VENTURA RIVER WATER DISTRICT

Valley Meadow Drive Water Main – Phase 2

ADDENDUM NO. 1

VENTURA RIVER WATER DISTRICT	
VALLEY MEADOW DRIVE WATER MAIN	
VALLEY MEADOW DRIVE PIPELINE	
STA 7+00 - 13+00	
DESIGNED BY: JMT	DRAWN BY: ADS
CHECKED BY: JMT	DATE: 1-18-19
REGISTERED CE: 60214	EXP. DATE: 6-30-20
DRAWING NO. C-02	
SHEET 5 OF 10

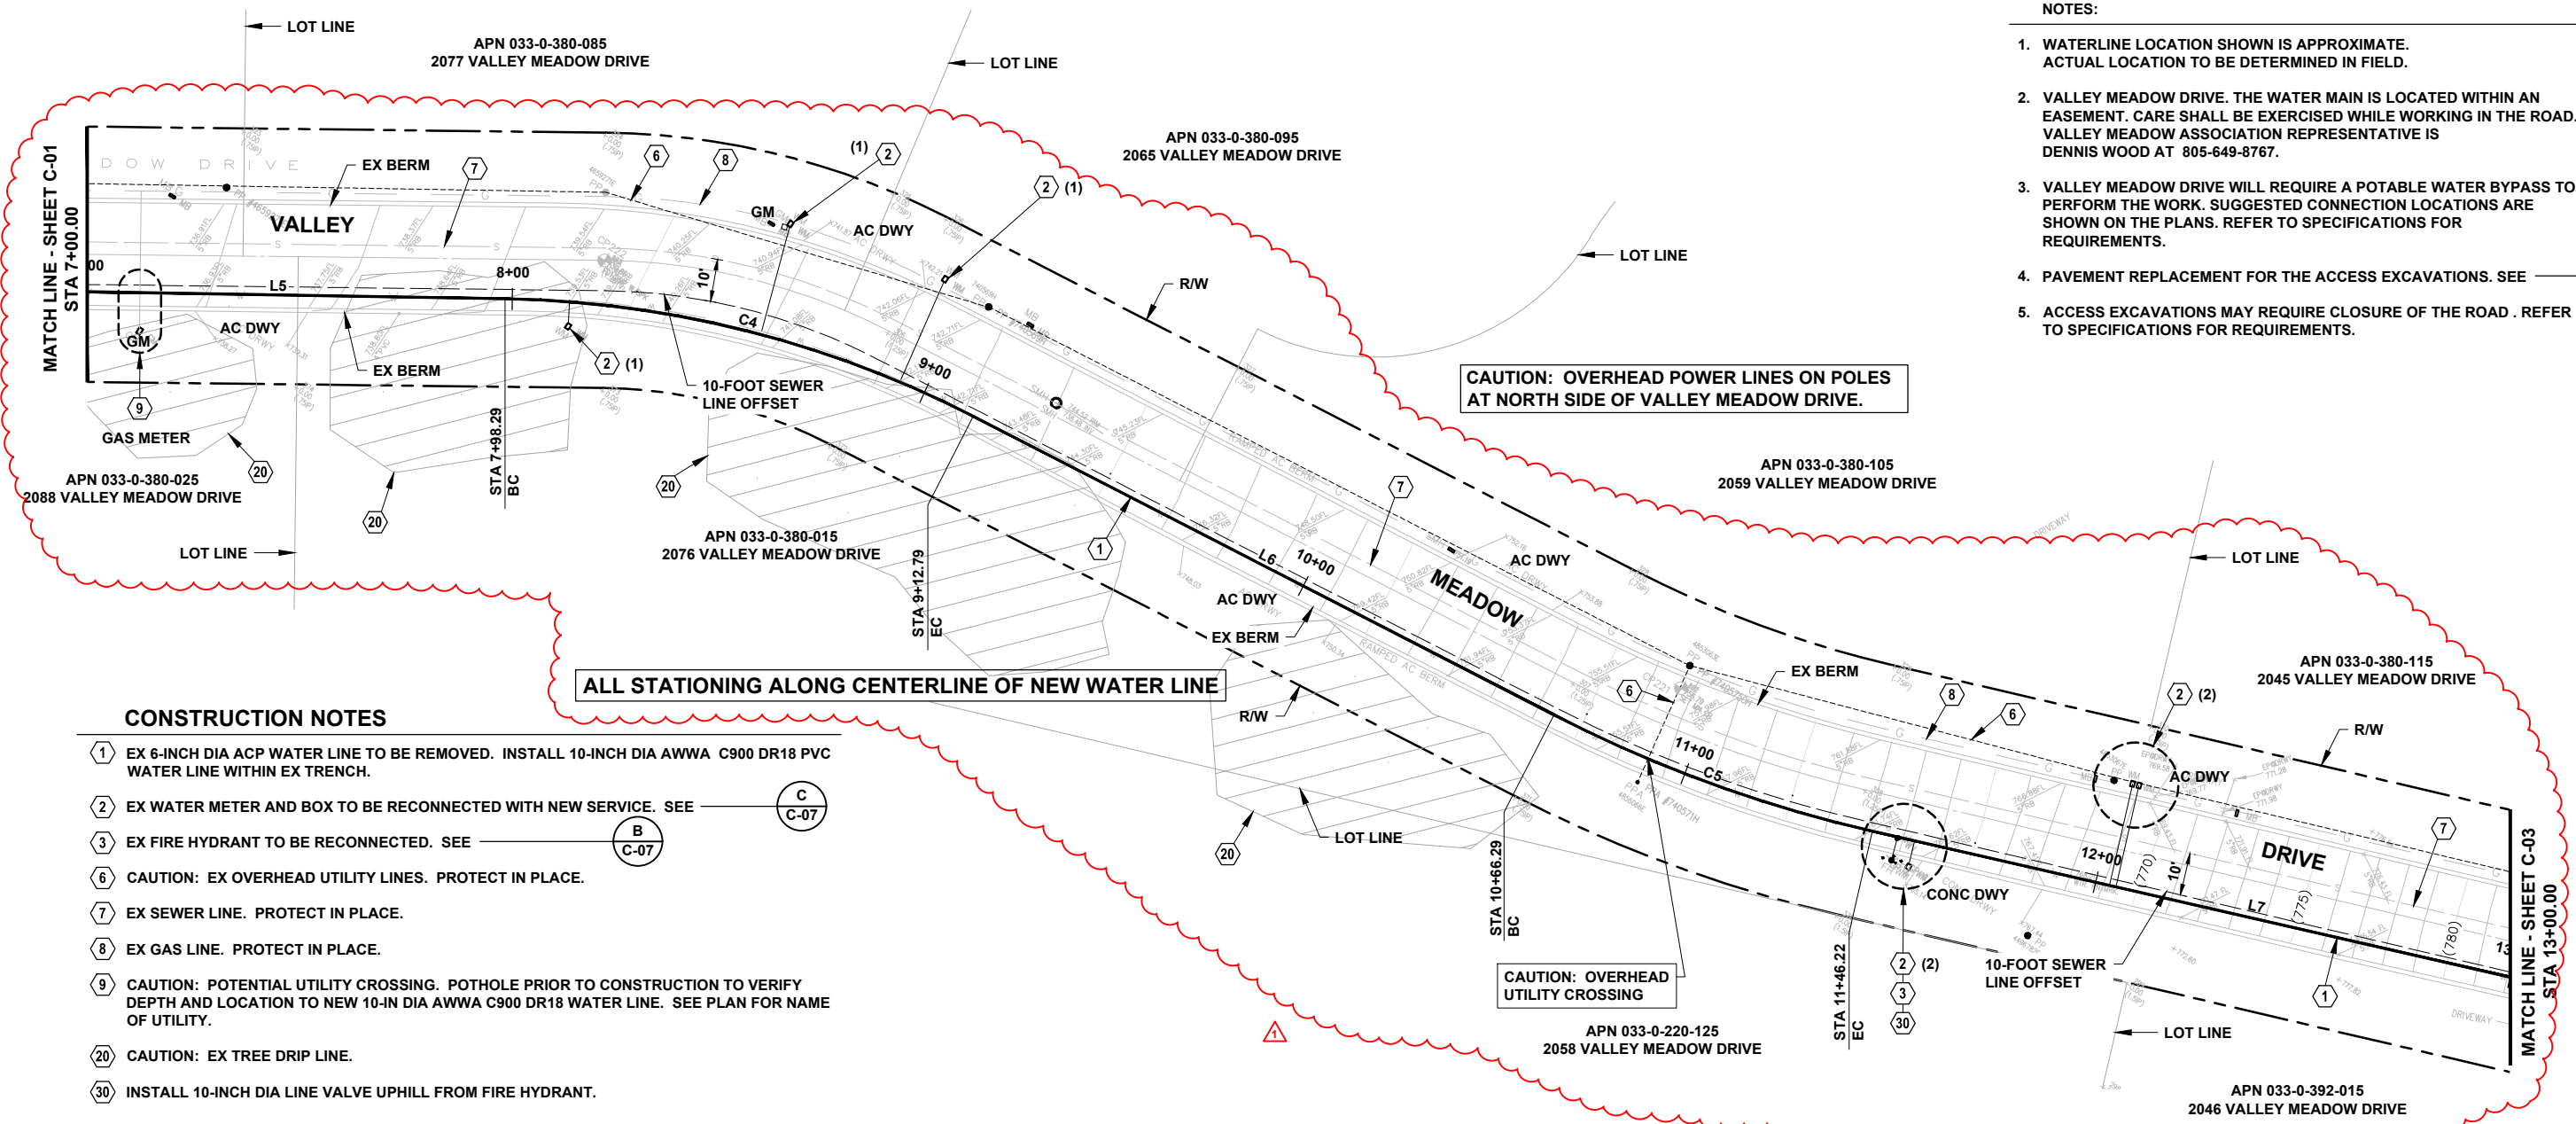
Item AD1-18 Add the following note to Sheets C-01 through C-03:

“Note: A temporary water service (highline) will be required to serve the existing water customers on Valley Meadow Drive from Station 1+00 to Station 17+18.92 during construction of the new 10-inch water main.”
